STATE OF MICHIGAN
DEPARTMENT OF ENVIRONMENTAL QUALITY
LANSING

August 20, 2009

SUBJECT: G&H Landfill Superfund Site, Review of January – July 2008 Report

Charts 9 - 19

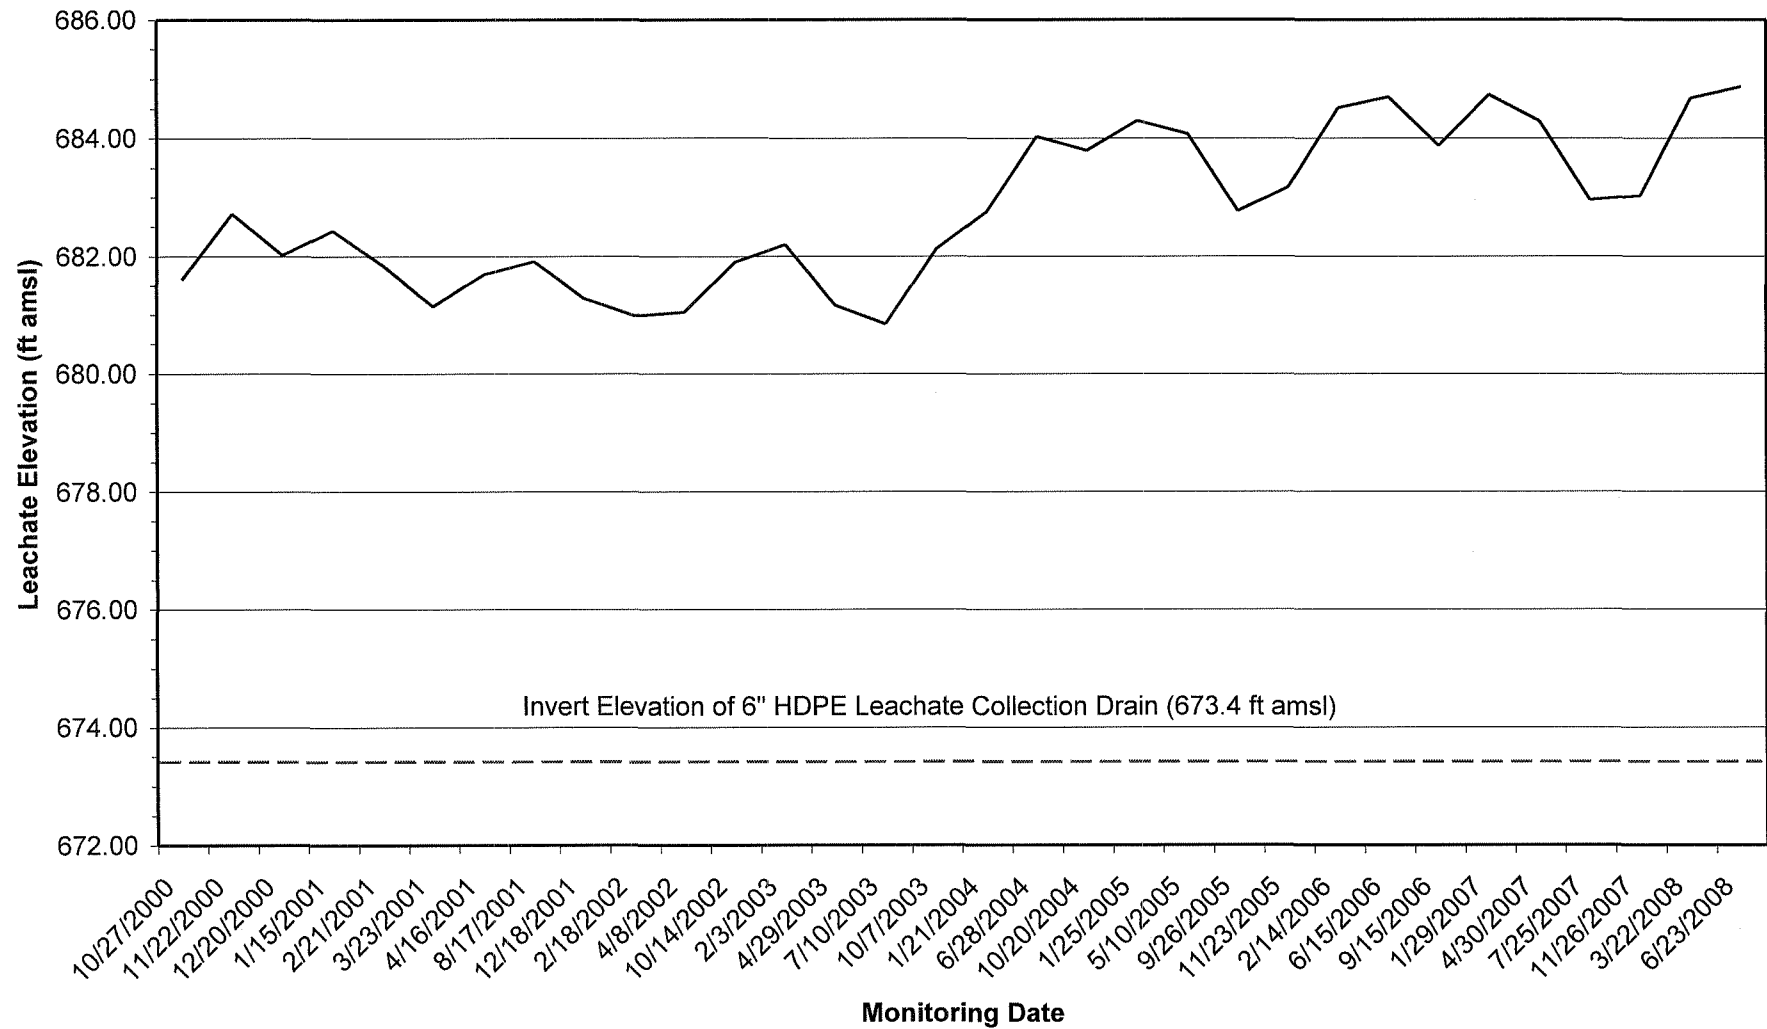
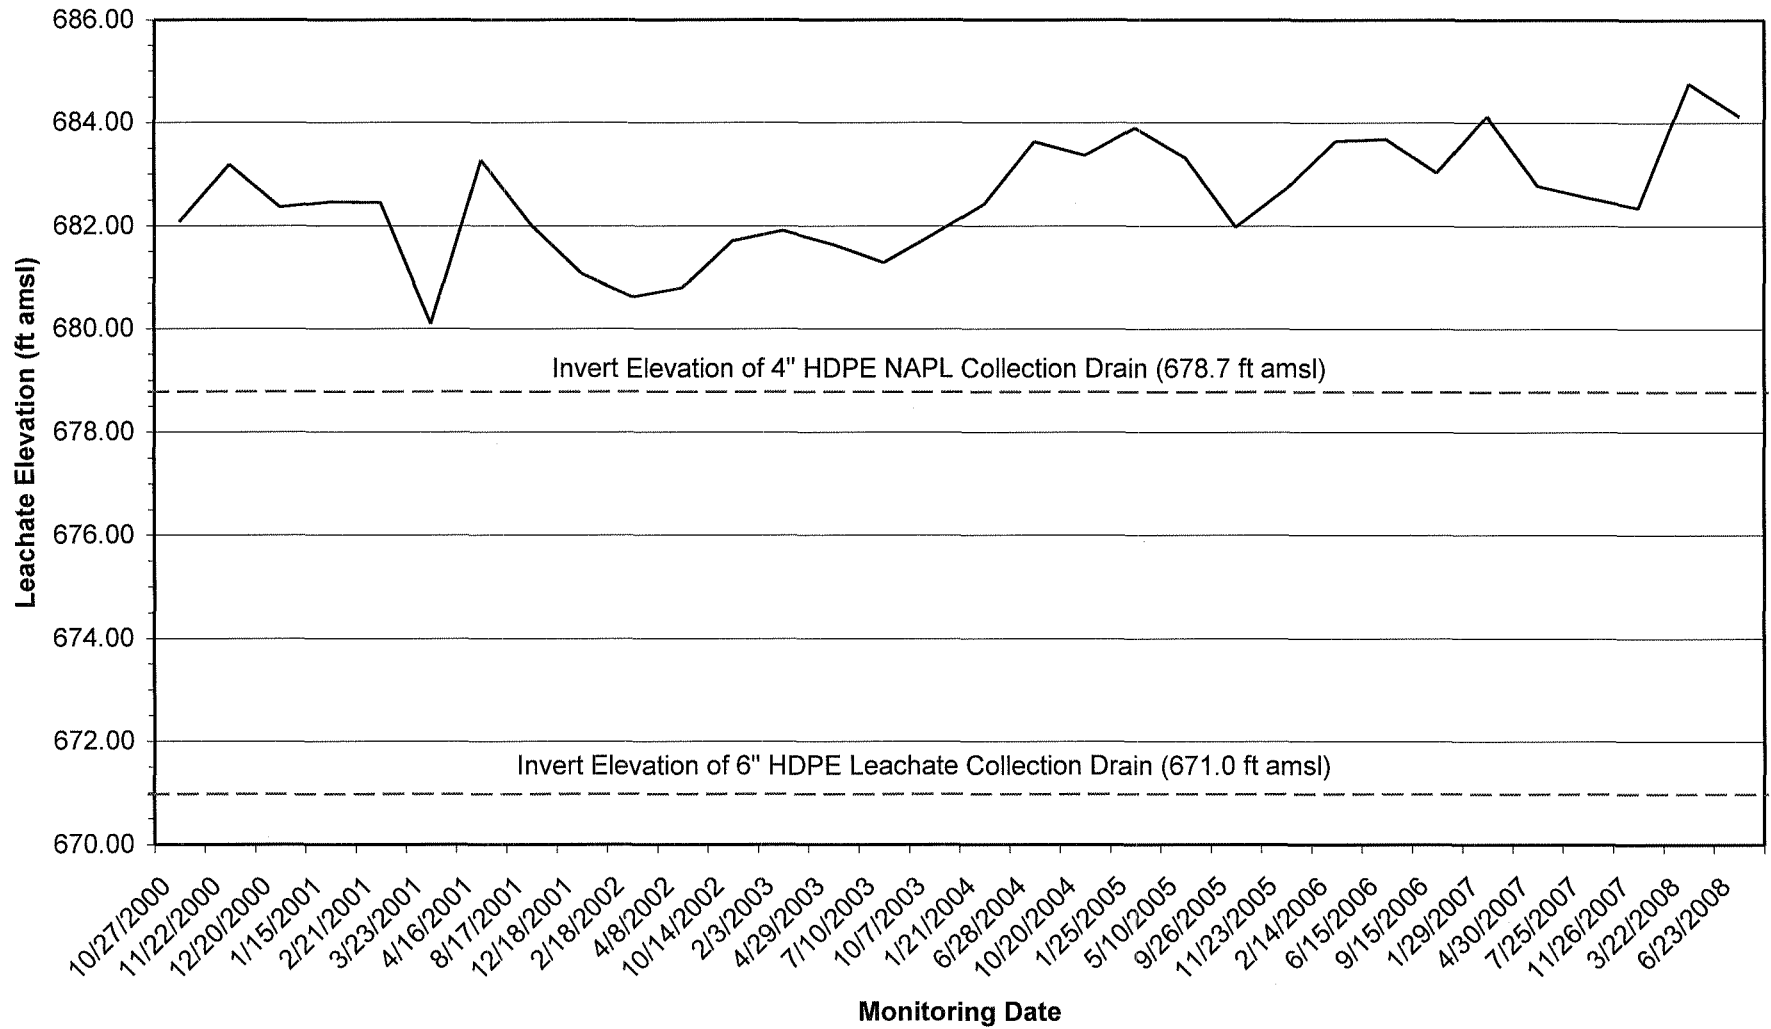
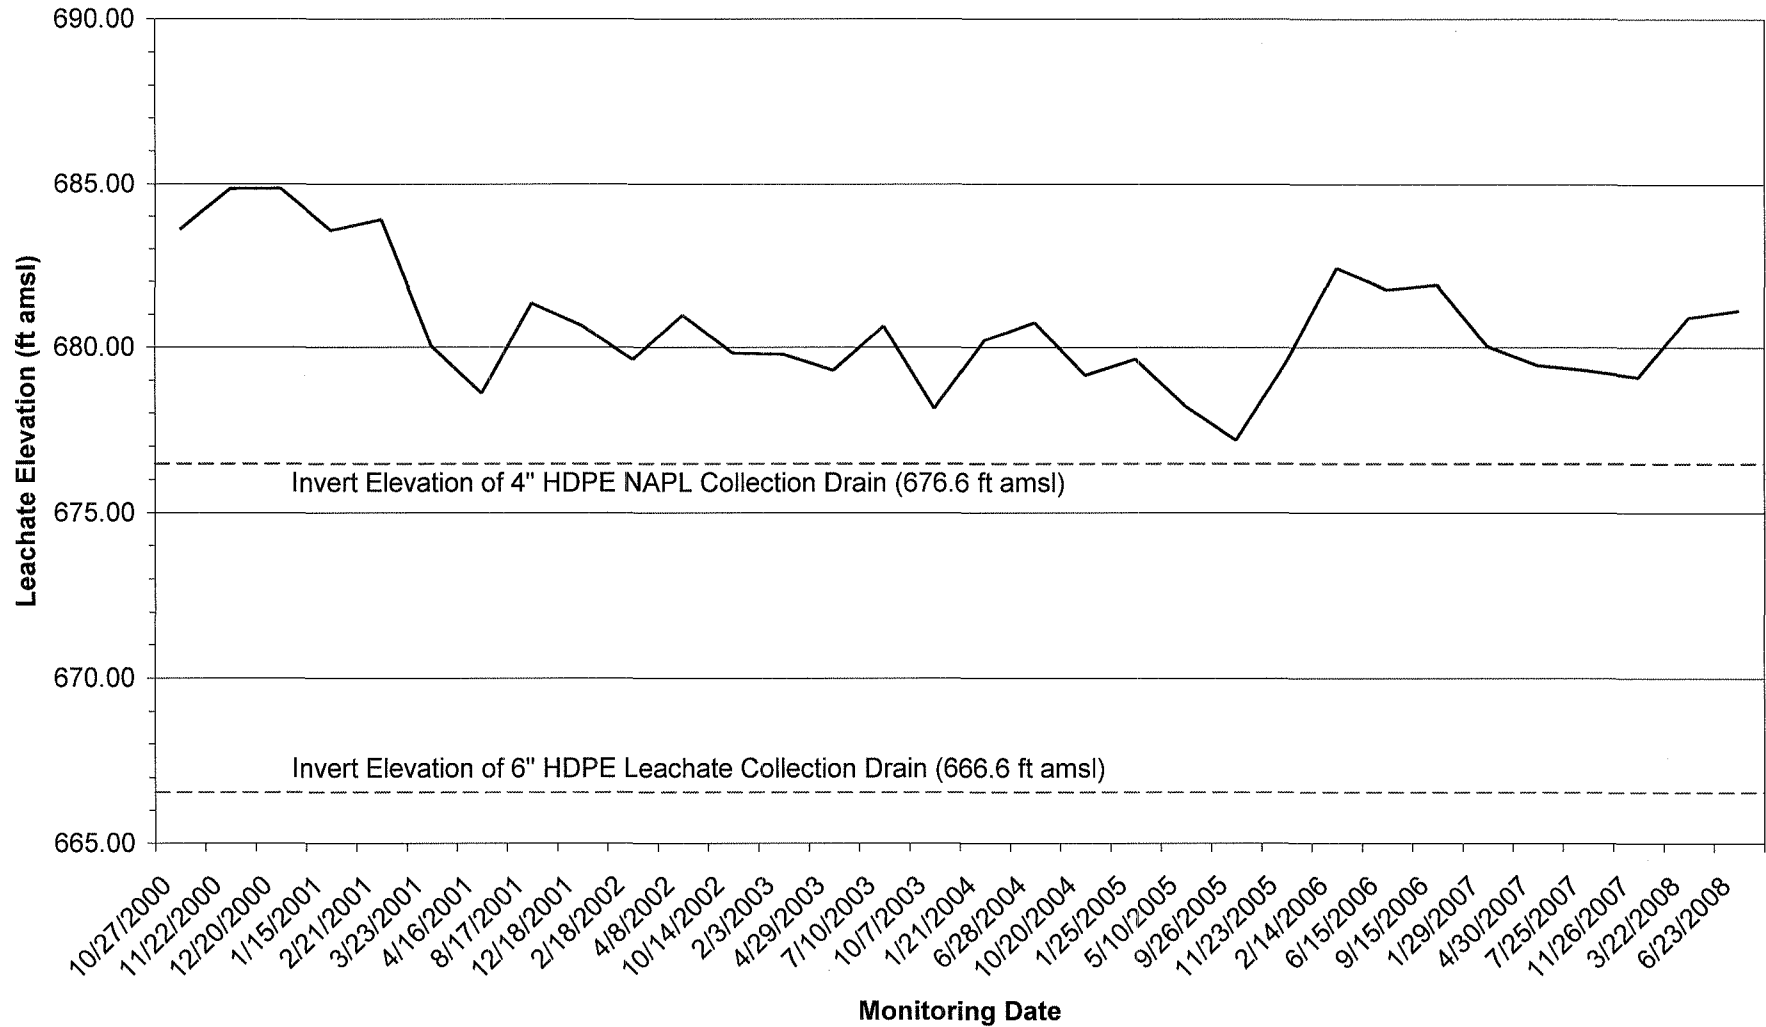
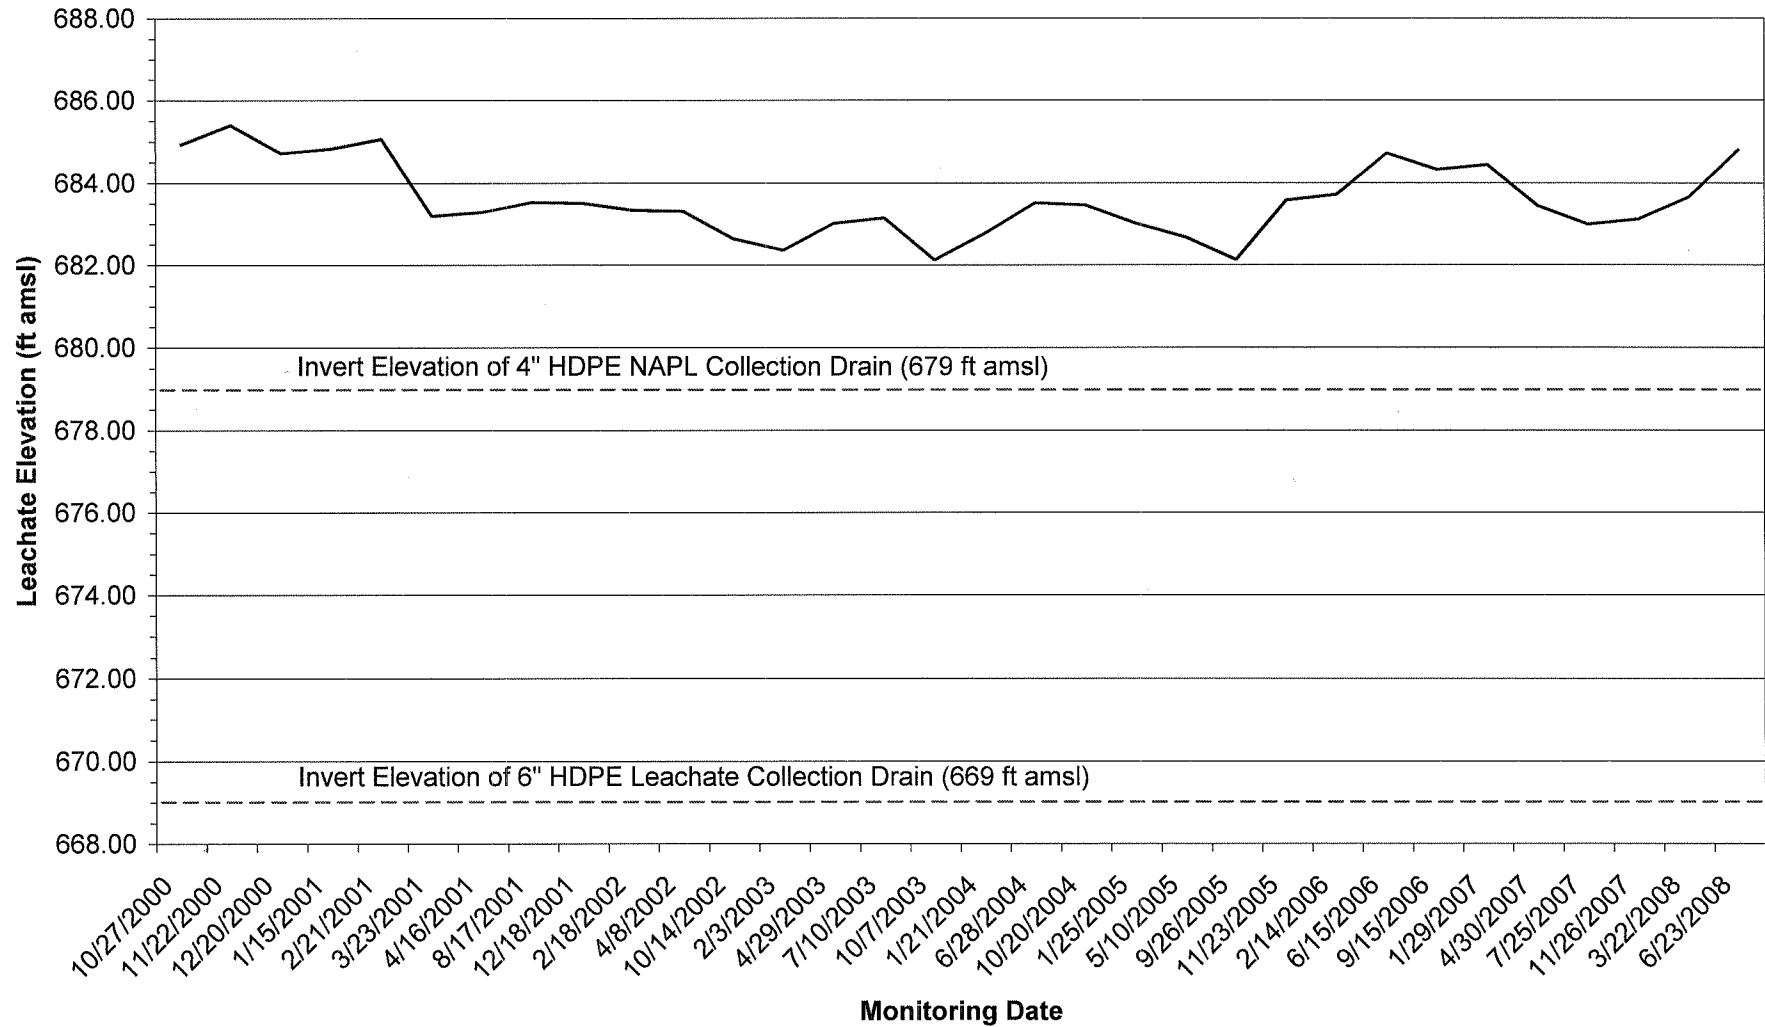
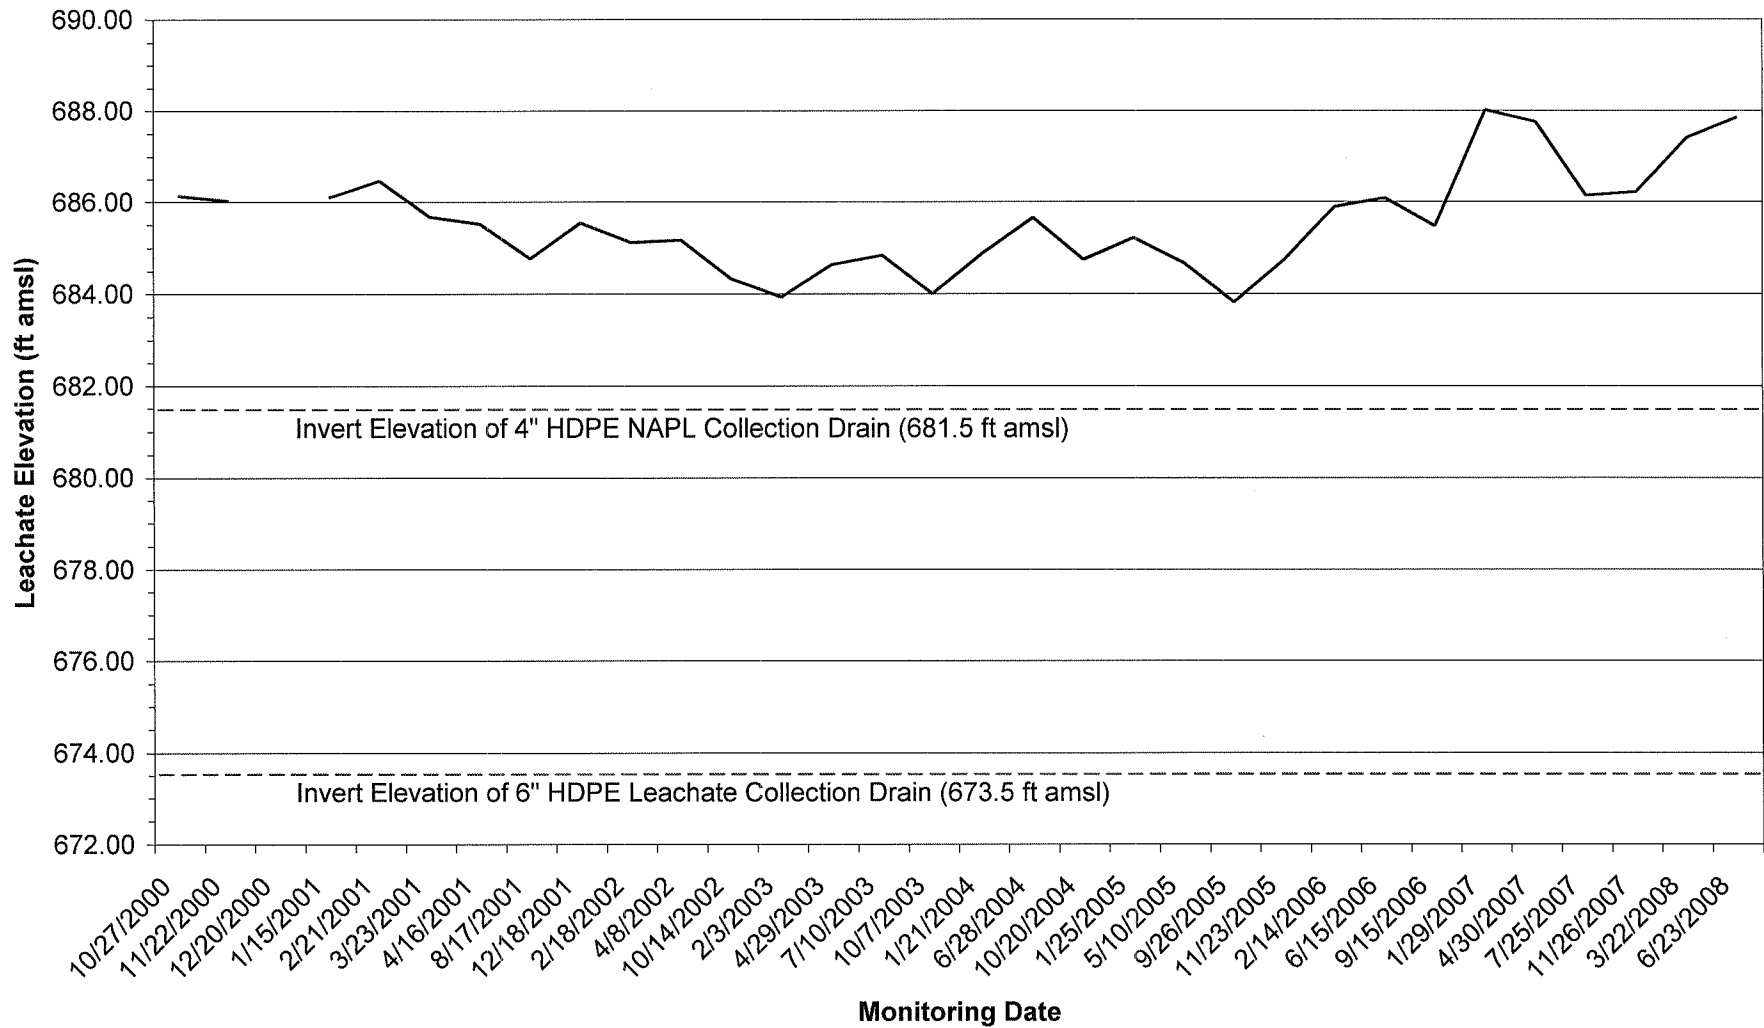
CRA reports water levels inside the barrier wall have remained stable. Water level trend charts, prepared by the MDEQ, are attached (Attachment B, Charts 9 - 16) for monitoring wells GH-52, GH-54, GH-56, GH-58, GH-60, GH-78, GH-80, and GH-82. The charts show water levels over time compared to the collection pipe invert elevations of the barrier wall collection system. The barrier wall collection system consists of a 6-inch high-density polyethylene (HDPE) leachate collection pipe and a 4-inch HDPE pipe, constructed approximately 10 feet above the 6-inch leachate collection pipe, to collect non-aqueous phase liquids (NAPL). The following observations are illustrated from the water level trend charts:

- Water levels have fluctuated approximately 2-3 feet seasonally within the capped cells with increasing trends observed at GH-52, GH-54, and GH-60 throughout the past 8 years of operation;
- Water levels have significantly exceeded the collection pipe inverts of the collection system throughout the past 8 years of operation;
- June 23, 2008, water levels at monitoring wells inside of the slurry wall range from 11.5 feet at GH-5 to nearly 16 feet at GH-80 above the invert¹ of the 6-inch HDPE leachate collection pipe; and
- June 23, 2008, water levels ranged from 3.75 feet at GH-78 to over 6 feet at GH-60 above the invert of the 4-inch HDPE NAPL collection pipe.

In summary, hydraulic and chemical data reviewed in this report do not present successful performance of the barrier wall and collection system at many monitoring locations. Additionally, the water level observed above the NAPL collection piping eliminates the ability of the collection system to retrieve NAPL.

- Implement the approved corrective action plan to achieve hydraulic and physical containment of the source areas;
- Execute contingency plans to achieve the 2-feet inward gradient at the barrier wall and maintain water levels to allow the collection of NAPL from the Phase I and Phase II landfill cells as required in the SOW;
